CITY PLANNING COMMISSION

- APPLICATION:
- A. Negative Declaration
 - B. Special Permit for deep lot development with an infill density bonus to allow four duplexes on 0.8+ vacant acres in the Single Family (R-1) zone
 - C. Lot Line Adjustment to relocate the common property line between 2 lots on 1.4 partially developed acres

LOCATION: 1044 Sonoma Avenue, 3042 Branch Street

P86-348

SITE PLAN

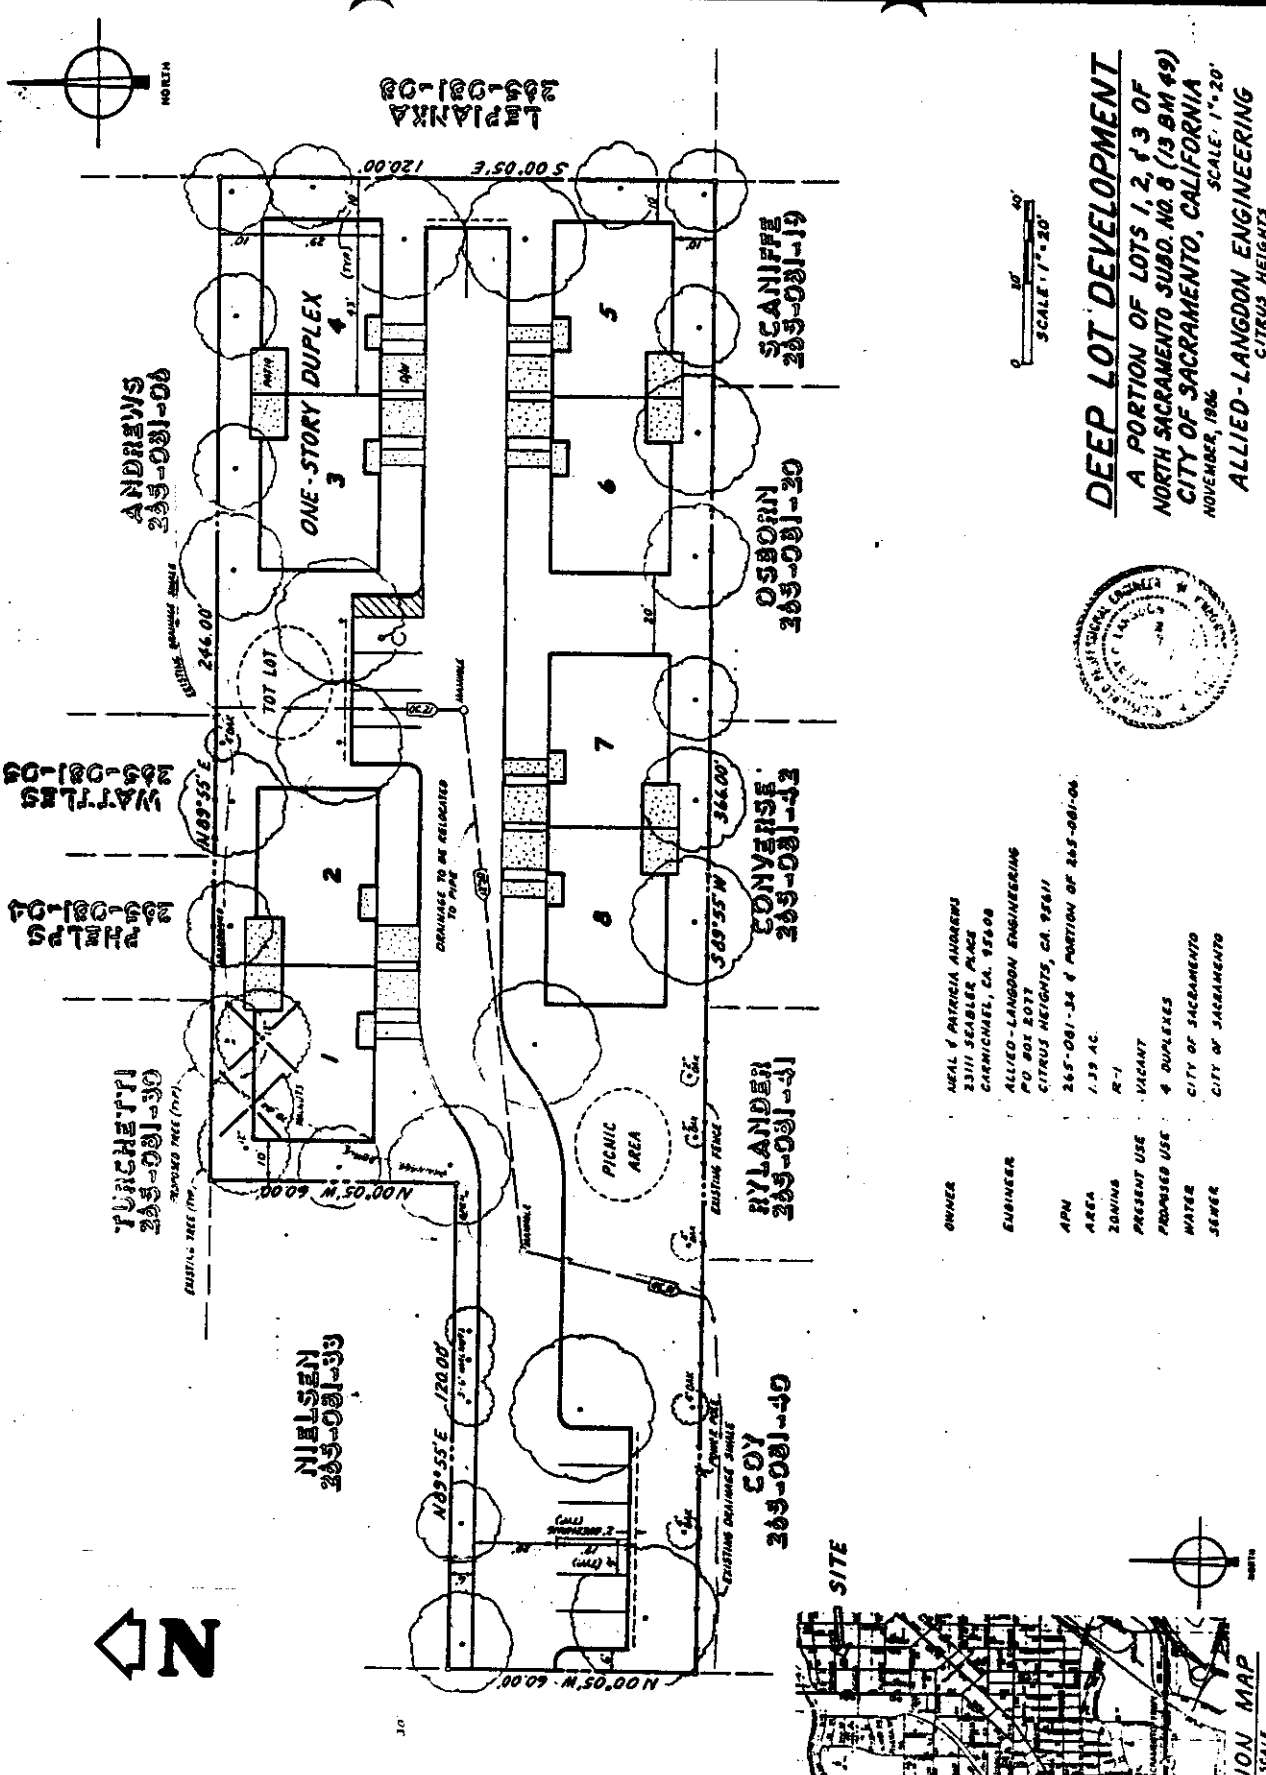
- F. Design of Parcel 34: The proposed project has been reviewed for consistency with the deep lot development guidelines. The size of the units and the inclusion of garages and washer-dryer hookups are positive elements of the design. The street orientation, exterior materials and setbacks do not meet the intent of the guidelines. Regarding street orientation, the front unit should have its entry facing the street rather than a side on orientation. The front unit should either be a single unit or give the appearance of a single family home, in order to be compatible with the character and streetscape of the area. The exterior materials used should complement the surrounding area and set an example for upgrading the area. The setbacks should exceed the minimum five feet wherever possible, especially where the side yard area serves as the functional rear yard of the deep lot units. If private yards or patios are provided, access to these spaces should be directly from the adjoining room.

1. provide 24 foot width for two way driveway
2. provide 26 foot maneuvering width

5. the exterior materials used shall be horizontal wood siding, stucco or wood shingle; not T-111;
6. window trim should be as per attached Exhibit B;
7. Revised site plan and elevations shall be submitted to the Planning Director for review and approval prior to issuance of building permits.

**EXHIBIT A
SITE PLAN
ALTERNATIVE**

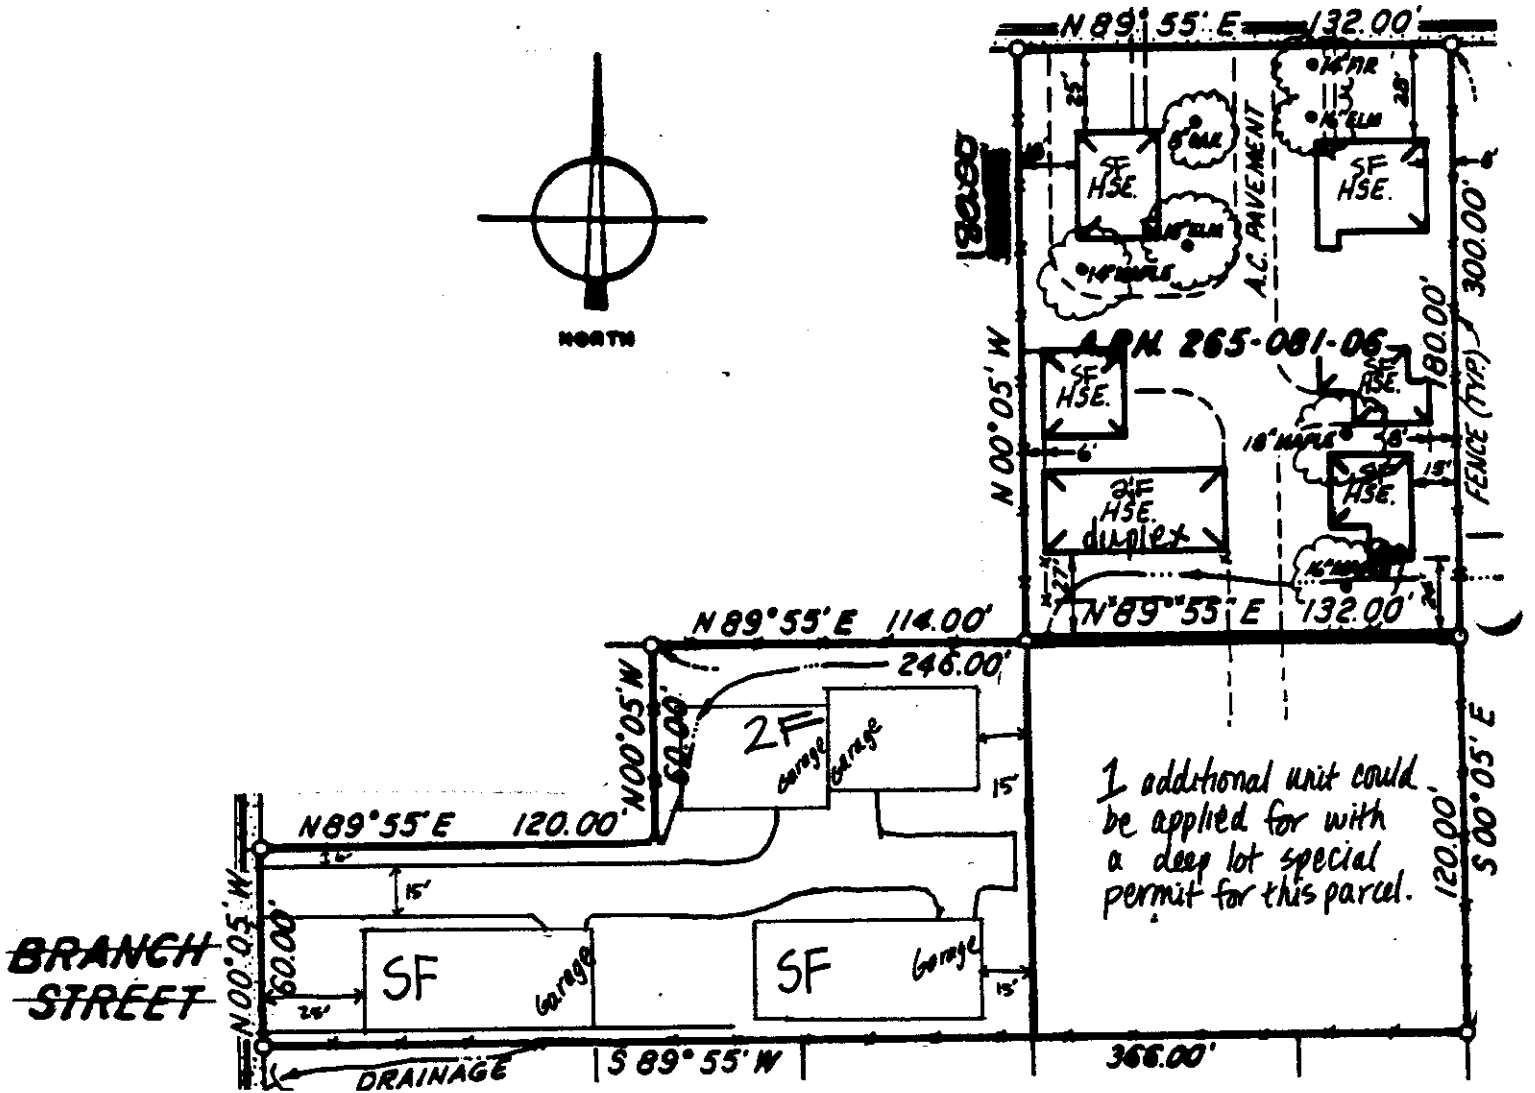
- G. Staff Alternative Site Plan for Parcel 34: Based on a capacity of four dwelling units, which staff feels is the most that can be accommodated on the site while meeting City standards, staff has prepared an alternative schematic site plan for the site. This alternative, along with conditions of approval, is supported by staff and is attached to this report as Exhibit A.

1. the total number of dwelling units permitted on parcel 226-081-34, shall be four as indicated by exhibit A;
2. the single family unit facing Branch Street shall have front door and window orientation to Branch Street and be designed to reflect the traditional single family residential character of the area;
3. the rear single family and duplex units shall be oriented to the driveway, with living areas designed to take advantage of usable open space;
4. the duplex shall be designed to break up the continuous roof line, such as by offsetting the units;
